Staff Report

REPORT NO.: DSD-2023-418

SUBJECT: Heritage Permit Application HPA-2023-V-021
107 David Street
Alterations to existing rear addition and replacement or alteration of windows

Figure 5: Architectural Drawing of Proposed Rear Alterations

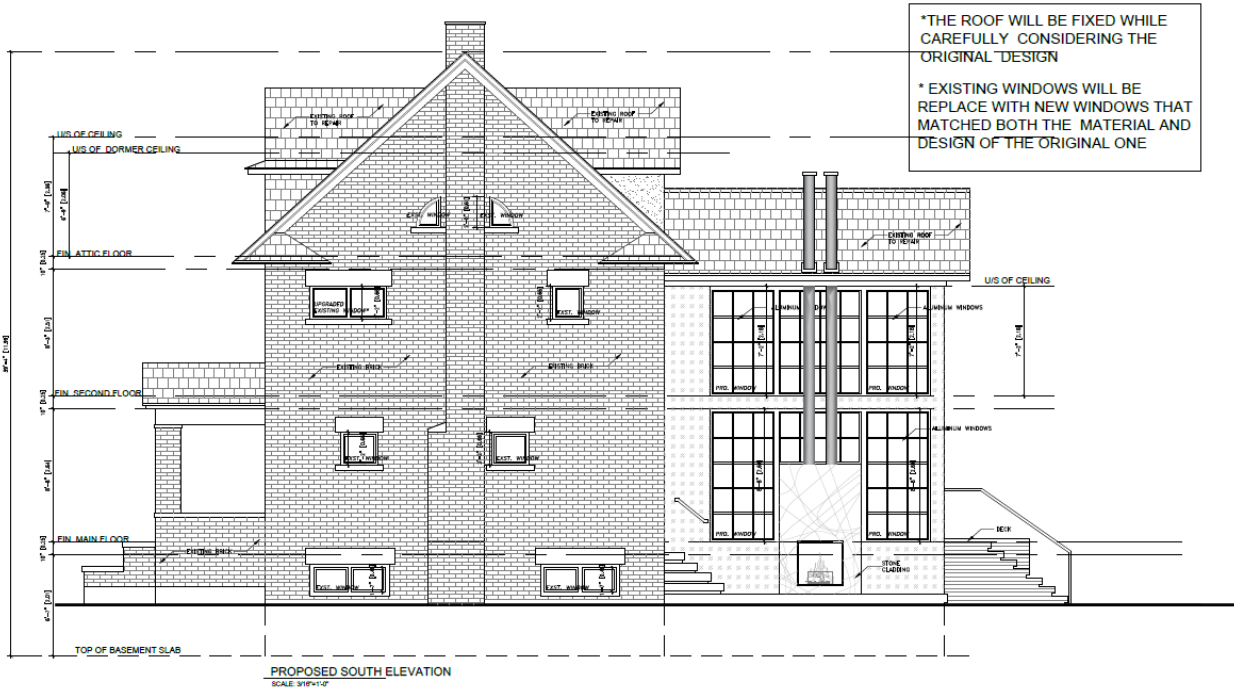
This heritage permit application is proposing alterations to the fenestration and cladding of the east and south facades of the rear addition. New black aluminum windows are proposed with surrounding matching aluminum cladding to create a cohesive façade. The new windows are proposed to be between 12-16 pane, in a style that is distinct from the existing windows of the dwelling but complimentary to the building and in keeping with the historic character of the area. The existing two-storey deck and staircase at the rear is proposed to be removed and replaced with a new patio area with an outdoor stone-clad fireplace.

The appearance of the north façade of the addition will be largely unchanged. The existing stucco and brick cladding is to remain, though a new multi-pane window is proposed on the second floor and the existing ground-floor window is proposed to be replaced with a 12-pane aluminum window.

Area of Proposed Work	Comment
Alterations to Rear Addition	<ul style="list-style-type: none"> The addition is not original to the property and was not built close to the original construction date.
Alterations to Rear Addition	<ul style="list-style-type: none"> There are no changes proposed to the footprint of the addition.
Alterations to Rear Addition	<ul style="list-style-type: none"> While aluminum siding is not typical for the character of the area, limited amounts of the material are proposed in this application. Most of the new façade will consist of the large multi-paned windows.
Alterations to Rear Addition	<ul style="list-style-type: none"> The new windows proposed on the rear and rear-side of the addition are distinct from the original windows but complimentary and compatible in design.
Alterations to Rear Addition	<ul style="list-style-type: none"> The proposed alterations to the fenestration and siding will only be visible from the pedestrian pathway adjacent to the property. Some screen is already provided by existing vegetation. The implementation of additional screening measured is a condition of approval.

- a) That the existing vegetation in the rear yard be maintained if feasible and additional screening measures be identified for implementation along the southwestern property line to the satisfaction of Heritage Planning Staff prior to the issuance of a building permit;
- b) That samples of proposed materials be submitted to Heritage Planning Staff for review prior to the issuance of a building permit;
- c) That a complete list and documentation identifying damaged windows to be replaced be provided to Heritage Planning Staff for review prior to the issuance of a building permit; and
- d) That final building permit drawings be reviewed, and heritage clearance provided by Heritage Planning Staff prior to the issuance of a building permit.
